TECH BULLETIN

084
11/99

SUBJECT: Crankcase Change - 60 Frame

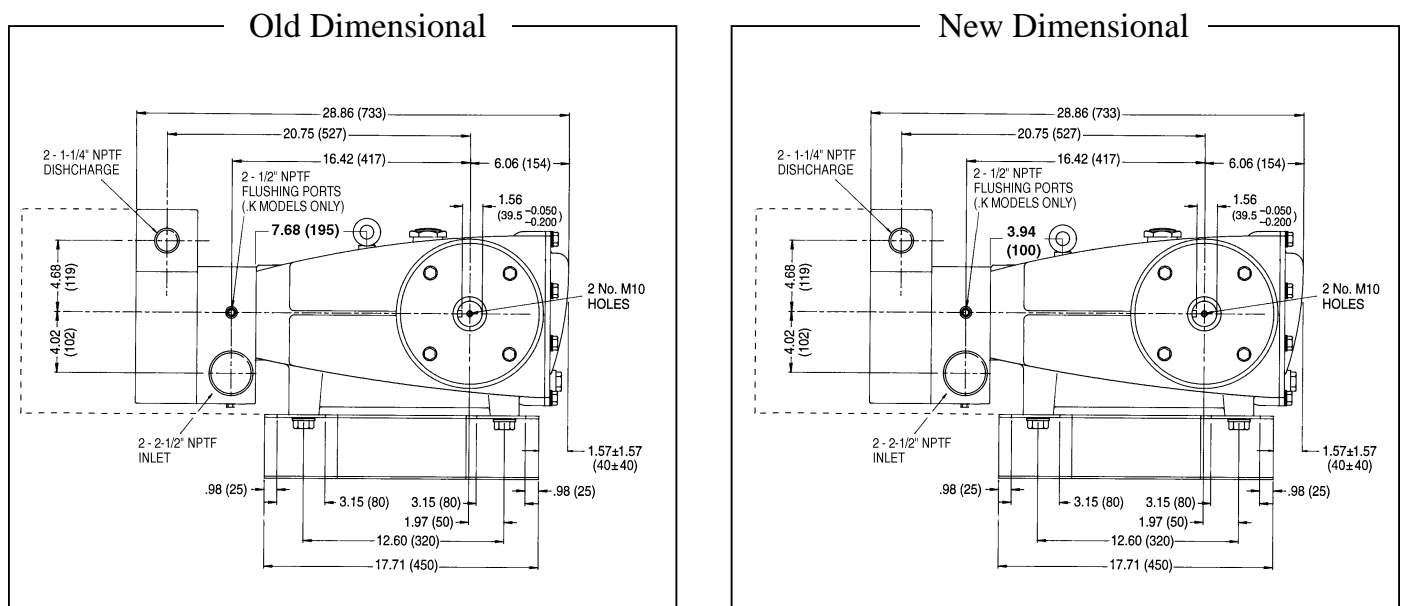
The 60 Frame Crankcase lifting eye bolt has been relocated to a more forward position. This has been done to provide better balance with the increase popularity of the block-style heads. This change will take place approximately January 2000 and the crankcase PN 43284 will continue to be used. A recess has also been added at the top of the crankcase for the label.
